LOCATION: Peak Street, North of Munger Avenue**DATE FILED:** April 6, 2023**ZONING:** MF-2(A)**CITY COUNCIL DISTRICT:** 2 **SIZE OF REQUEST:** 0.390 acres**MAPSCO:** 45D**APPLICANT/OWNER:** Highfield Partners 1, LLC

REQUEST: An application to create an 8-lot shared access development with lots ranging in size from 1,618 square feet to 3,057 square feet from a 0.390-acre tract of land containing part of Lot 11 and all of Lots 12 through 14 in City Block 10/658 on property located on Peak Street, North of Munger Avenue.

PRELIMINARY PLAT

OUT OF THE
JOHN GRIGSBY SURVEY, ABSTRACT NO. 48
CITY OF DALLAS, DALLAS COUNTY, TEXAS
CITY PLAN FILE NO. S223-123

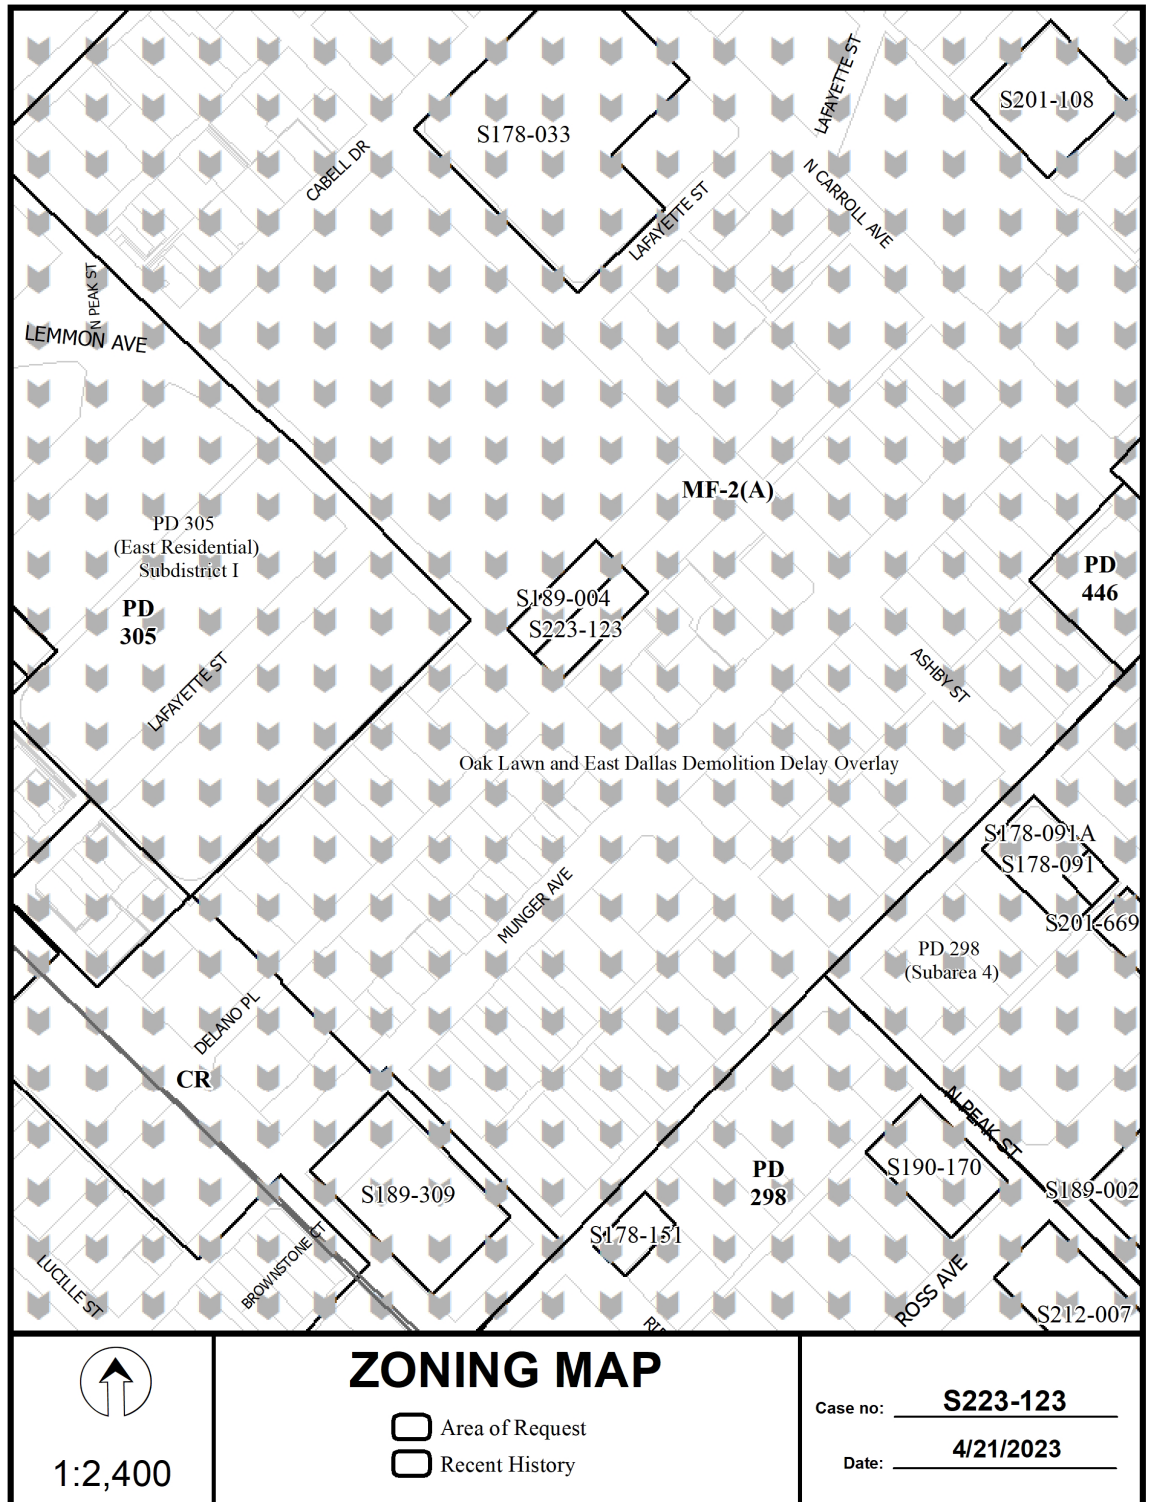
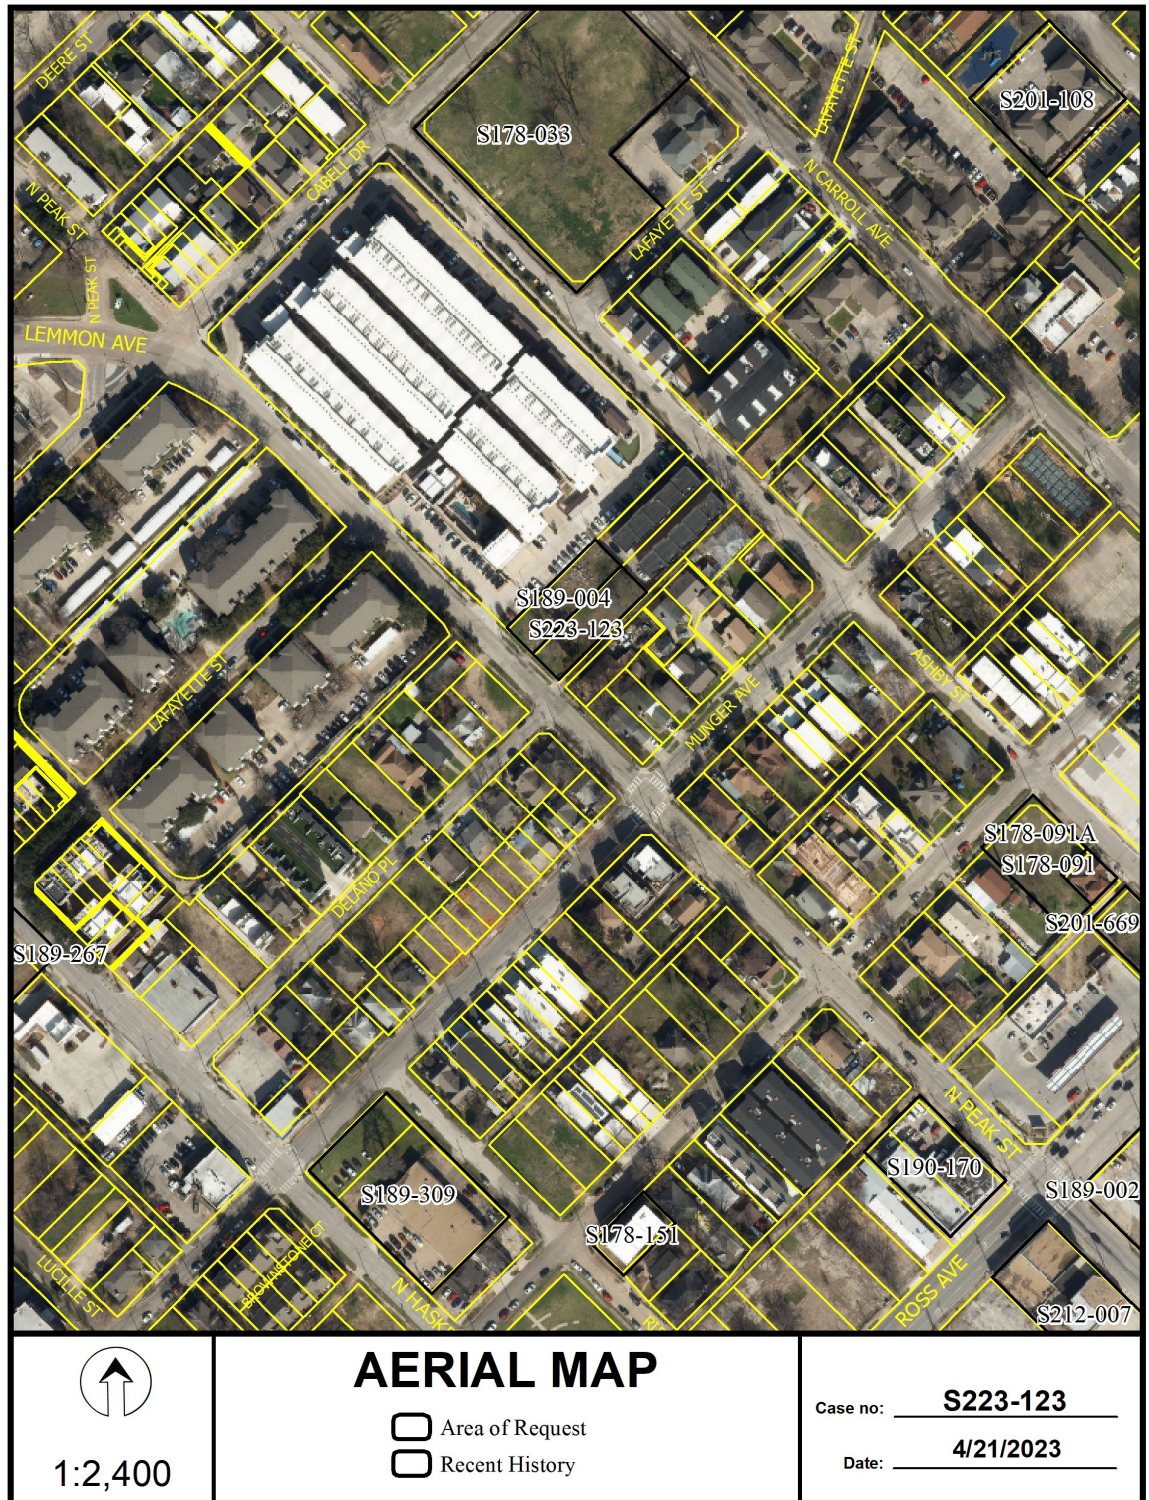
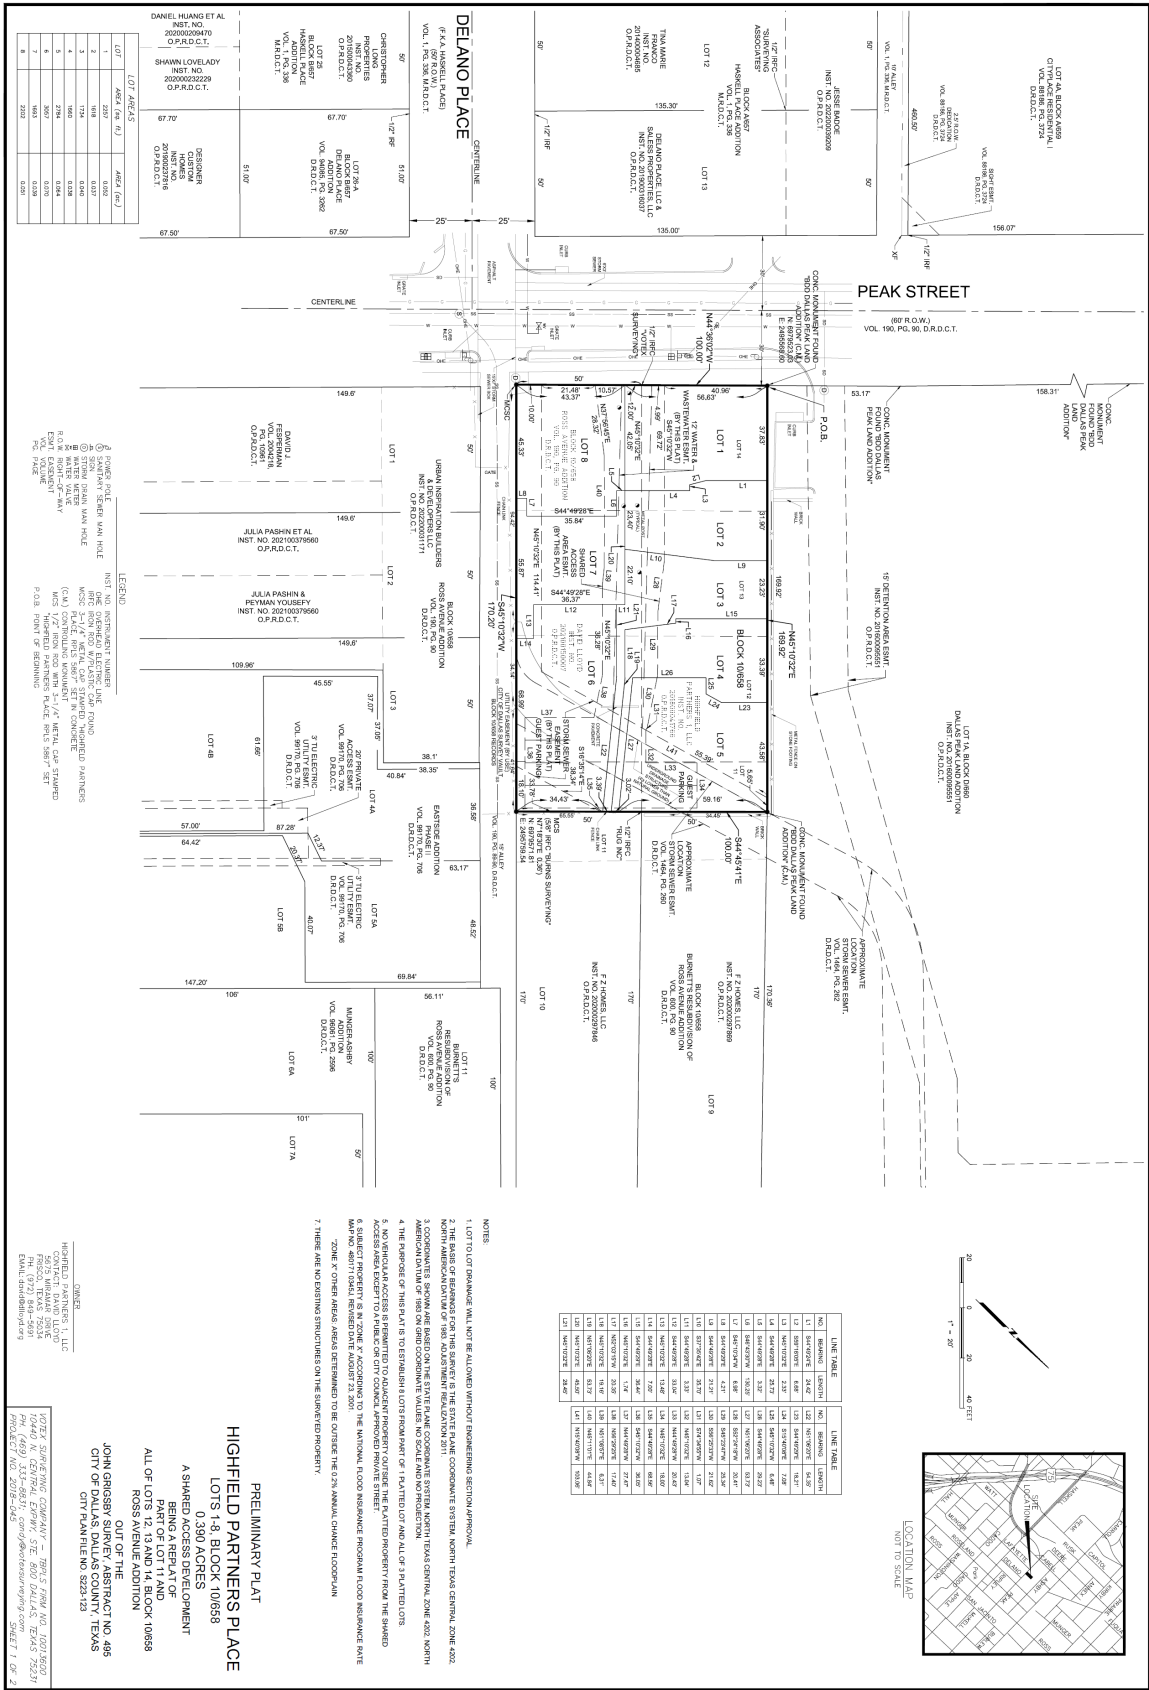
STAFF RECOMMENDATION: Section 51A-8.503 states that “lots must conform in width, depth and area to the pattern already established in the adjacent areas, having due regard to the character of the area, its particular suitability for development, and taking into consideration the natural topography of the ground, drainage, wastewater facilities, and the proposed layout of the streets.”

Staff finds there is not an established lot pattern in the immediate area of request and request complies with the requirements of MF-2(A) Multi Family District and complies with the requirement of Section 51A-8.503; therefore, staff recommends approval of the request subject to compliance with the following conditions:

1. The final plat must conform to all requirements of the Dallas Development Code, Texas Local Government Code, Texas Land Surveying Practices Act and the General Rules and Regulations of the Texas Board of Land Surveying.
2. Department of Development Services, Engineering Division must verify that the plat conforms with the water, wastewater, and easement requirements under the provisions of Chapter 49 of the Dallas City Code.
3. Compliance with all plans, contracts, ordinances, and requirements of the City of Dallas. *Section 51A-8.102(a), (b), (c), and (d)*
4. The number and location of fire hydrants must comply with the Dallas Fire Code.
5. Any new or existing structure may not extend across new property lines. *Section 51A-8.503(e)*

6. On the final plat, all easement abandonments, and ROW abandonments must be by separate instrument with the recording information shown on the face of the plat. A release from the Real Estate Division is required prior to the plat being submitted to the Chairman for signature.

7. On the final plat, include two boundary corners tagged with these coordinates: "Texas State Plane Coordinate System, North Central Zone, North American Datum of 1983 on Grid Coordinate values, No Scale and no Projection."

8. On the final plat, monument all set corners per the Monumentation Ordinance. Prior to submittal of the final plat for the Chairman's signature. The monuments must be verified by the Chief City Surveyors Office in the Public Works Department. *Section 51A-8.617*

11. The number of lots permitted by this plat is eight.

15. On the final plat, dedicate a 15-foot by 15-foot Alley Sight Easement at the intersection of North Peak Street & the alley. *Section 51A-8.602(e)*

16. Comply with Mill Creek drainage requirements. Finish floor elevation must be 3' above nearest inlet, top of curb. 51A 8.611(d), C.9 of Mill Creek, Master Drainage Plan Study

17. Provide additional shared access area easement, up to 26 feet, for compliance to Dallas Fire Code when building height is 30 feet or greater.

18. A water and wastewater easement at least 12 feet wide to be used exclusively for public water and wastewater below grade must be provided within the Shared Access Area Easement & labeled on the plat. Section 51A-4.411(d)(2) and Sections 49-60(d), 49-61(c)(5)(B), and Development Design Procedure and Policy Manual Section 6.2

24. Include the words "Shared Access Development" in the title block of the final plat. Platting Guidelines
25. Place a note on the final plat stating: "No vehicular access is permitted to adjacent property outside the platted property from the shared access area except to a public or City Council approved Private Street." Section 51A-4.411(d)(3), and 51A-4.411(d)(10)

26. If a guard house is provided, it must be at least 30 feet from the shared access point. Section 51A-4.411(d)(8)
27. The Shared Access Area Easement must be terminated a minimum of 3 feet from the adjacent property or right-of-way. Section 51A-8.618(b)

28. Provide guest parking at a rate of 0.25 spaces per dwelling unit and with adequate maneuverability per the Shared Access Development requirements.
29. On the final plat, provide guest parking with adequate maneuverability per Shared Access development requirements City Code 51A-4.411(g) and all other requirements set forth by City Code 51A-4.411.

34. On the final plat, remove chain link fence from the alley notated on the plat and provide proof that fence in alley has been removed or is not encroaching into the alley.
35. On the final plat, change “Delano Place (F.K.A. Haskell Place)” to “Delano Place (F.K.A. Cochran Street) (F.K.A. Haskell Place)”Section 51A-8.403(a)(1)(A)(xii)
36. On the final plat, identify the property as Lots 11A through 11H in City Block 10/658. Ordinance 1A, Page 131 pages 131-148, Section 2 (passed August 13, 1872).
